## **Appendix 1 – Consultation on the proposed DCO Amendment**

**Appendix 6 – Transport Technical Note (by ADC Infrastructure)**

Northampton Gateway  
M1 J15, Northampton  
Illustrative Masterplan

Figure 7: proposed partial signalisation of the A508 site access junction

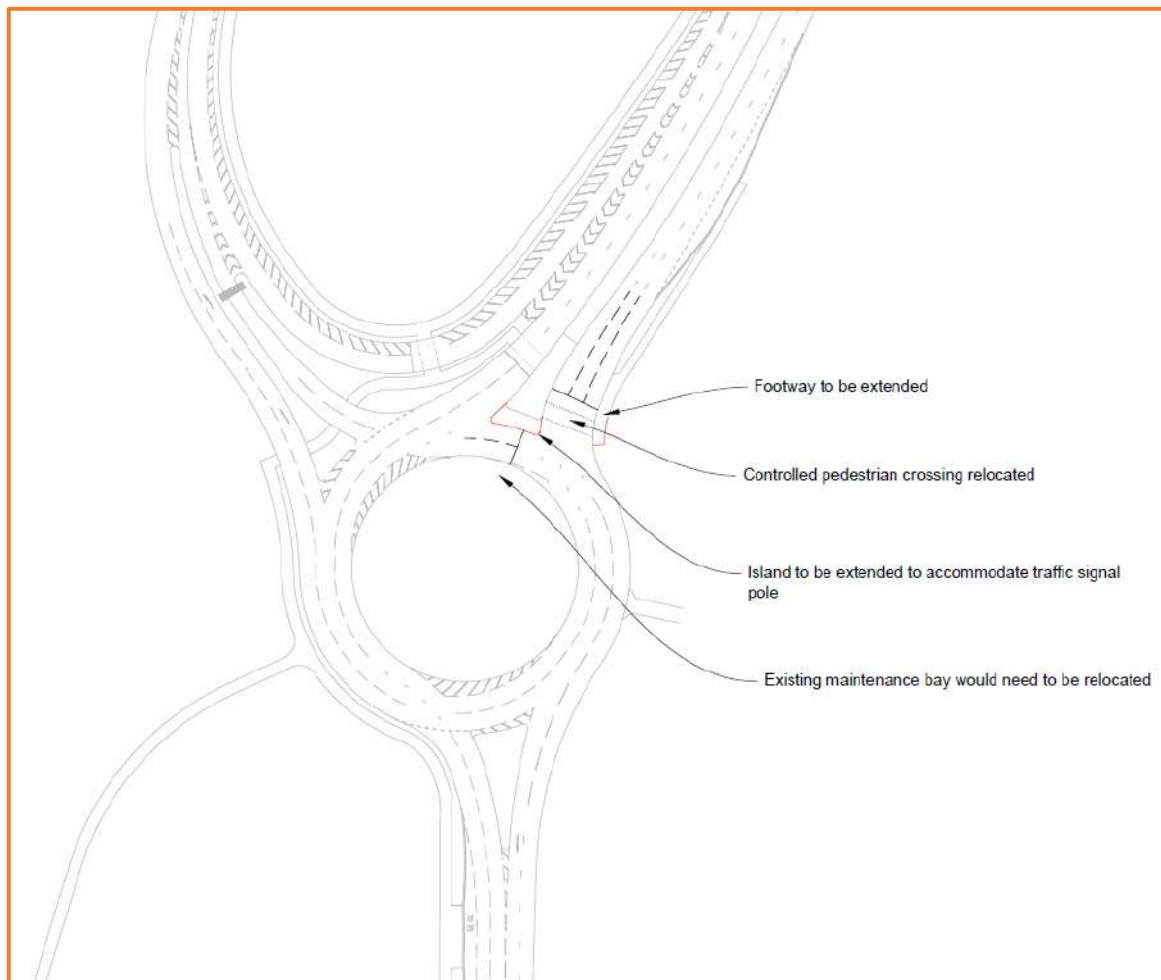
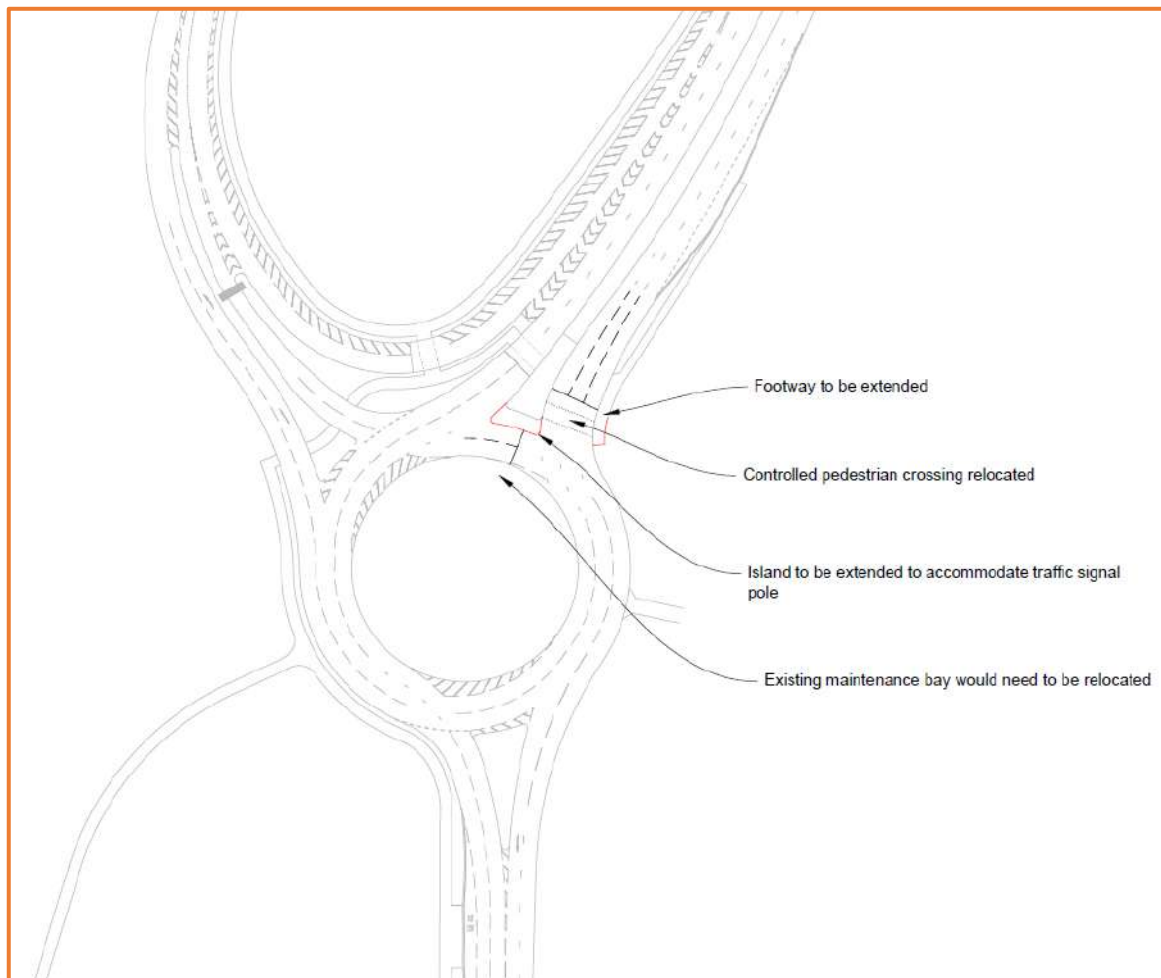
2.	<p>Model Structure: The northern circulatory (Arm 7), adjacent to the A508 Southbound approach, only shows a single lane. However, but Figure 7 in the “DCO Amendment” report shows it as two lanes. Is there a reason for modelling the arm in that way?</p>	<p>The right-turn flow from the site is relatively low and hence was modelled in a single lane for simplicity. However, the model has been amended to show two lanes.</p>
	<p>The site access arm (Arm 6) does not show the two lanes that enter the roundabout, but just a single lane (Arm 6, lane 2). Please can you explain why it has been modelled as a single lane?</p>	<p>As above.</p>
	<p>The LinSig model does not include the pedestrian crossings located on the A508 Northbound exit and the left turn on the site access arm. Please can you justify the exclusion of these two crossings from the model?</p>	<p>These crossings would be called infrequently and would not impact on the overall performance of the junction.</p>

2. Model Structure: The northern circulatory (Arm 7), adjacent to the A508 Southbound approach, only shows a single lane. However, but Figure 7 in the “DCO Amendment” report shows it as two lanes. Is there a reason for modelling the arm in that way?
